Glen Eira Planning Scheme Amendment C155

East Village

Panel Report pursuant to section 25 of the Act

11 February 2020

Figure 11 Excerpt from McPherson evidence report – Collins Street, Melbourne

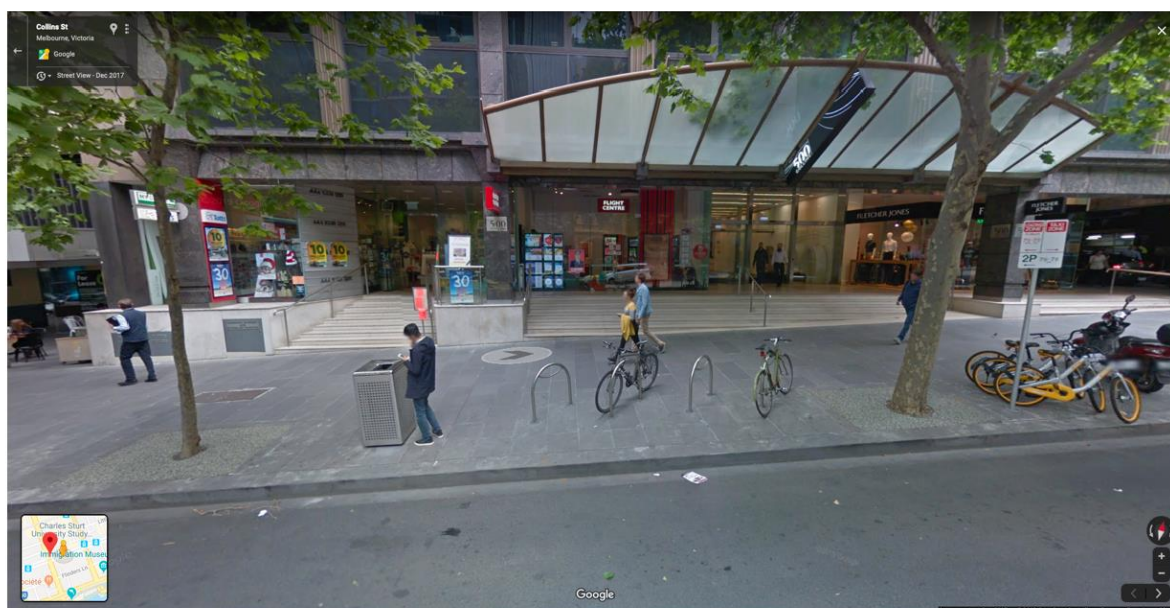
- Replace all nature strips with paving and include tree planting squares (refer to Figure 11) to accommodate footpath trading.
- Design North Drive as the central street in the precinct and as a contemporary boulevard with clear pedestrian priority.
- Provide demarcated cycling infrastructure on North Drive and potentially all streets.
- Include more widespread application of contemporary, innovative and pedestrian-priority streetscapes, such as shared spaces.
- Include provisions for pedestrian connections to break up street block lengths with separation distances for through links to provide a maximum effective block length of 50—70 metres.

Figure 14 East Village Structure Plan – Central Park

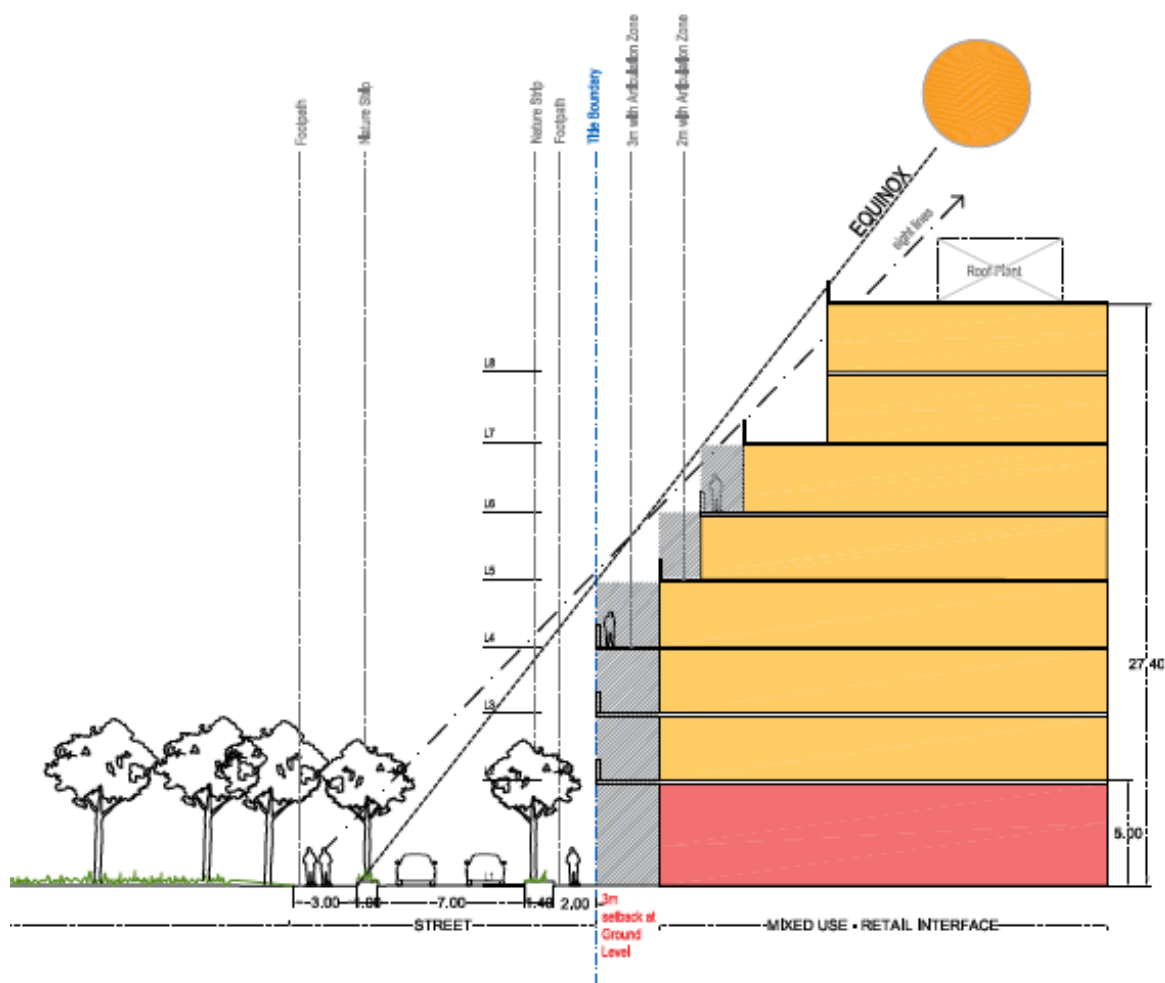
the Panel assumes is how the ‘paper road’ was intended to be developed. The EVSP refers to it as a “*pedestrian only street*” as shown in red cross hatching in Figure 14 that shows how Central Park might be developed with its peripheral street network. The MGS urban design report provides a section⁵⁴ through where the paper road is proposed (Figure 15). This shows a street reserve width of 14.4 metres with a pavement width of seven metres.

Mr McGauran could not advise the Panel where his reference to the 2.5 metre wide shared path came from, even though it is only contained in his evidence. The use of a narrower ‘road’ serves to exacerbate overshadowing effects on Central Park and the Panel found this part of Mr McGauran’s evidence unhelpful.

- **Include the overshadowing provisions proposed by Council in Document 46C.**
- **Show the continuation of the local access street width for the Central Park northern boundary and a shared road width to its west of 9 metres.**

Figure 16 Town Centre Concept Plan, exhibited CDP

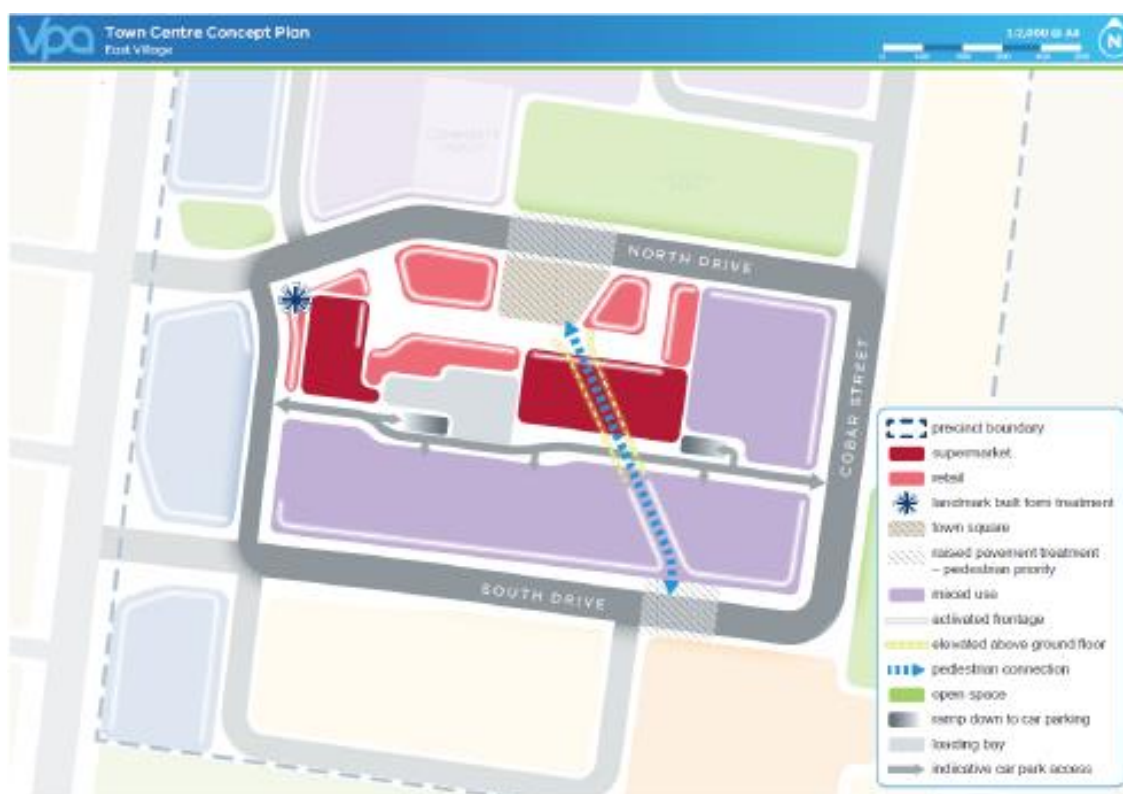
The Amendment does not specify a how many supermarkets the precinct should provide, although the Town Centre Concept Plan (refer to Figure 16) indicates two supermarket sites. This seems to be based on the MacroPlan Dimasi conclusion⁵⁷ that the precinct could support a full range supermarket of around 4,000 sqm and a second smaller supermarket of around 1,500 sqm. The Panel accepts that this is the probable outcome, although a single, larger format supermarket might also be a possibility.

Council’s closing submission described the exhibited Town Centre Concept Plan as “*inadequate*” and, to the extent that it seeks to implement Document 40, “*inappropriate*”. Council’s primary concern was that the Plan represented an internal mall style arrangement, rather than a street based, street activated configuration. Mr Reid shared Council’s view that the centre should be ‘street based’, rather than an internal mall. Council proposed that the Landowners prepare an agreed plan (based on Figure 12.0 in the EVSP⁶⁰) to replace the exhibited plan before the Amendment is adopted. Council also submitted that whatever plan is adopted, “*it should be identified as an indicative plan which illustrates one way that the Design Guidelines may transpire*”. Mr Reid suggested that the exhibited plan be deleted and that the Town Centre Design Guidelines be relied upon instead.

For these reasons, the Panel agrees with Council that the exhibited plan should not be included in the CDP, regardless of whether it is referred to as a 'preferred' or 'indicative' plan. The Panel is also reluctant to support the inclusion of the EVSP Figure 12.0 (or a version of it) in the absence of understanding how that plan was derived and without having tested its merits with the relevant experts at the Hearing.

- 16 Delete the Town Centre Concept Plan.
- 17 Ensure that requirements are drafted as 'mandatory' provisions and that guidelines are drafted as 'discretionary' provisions.
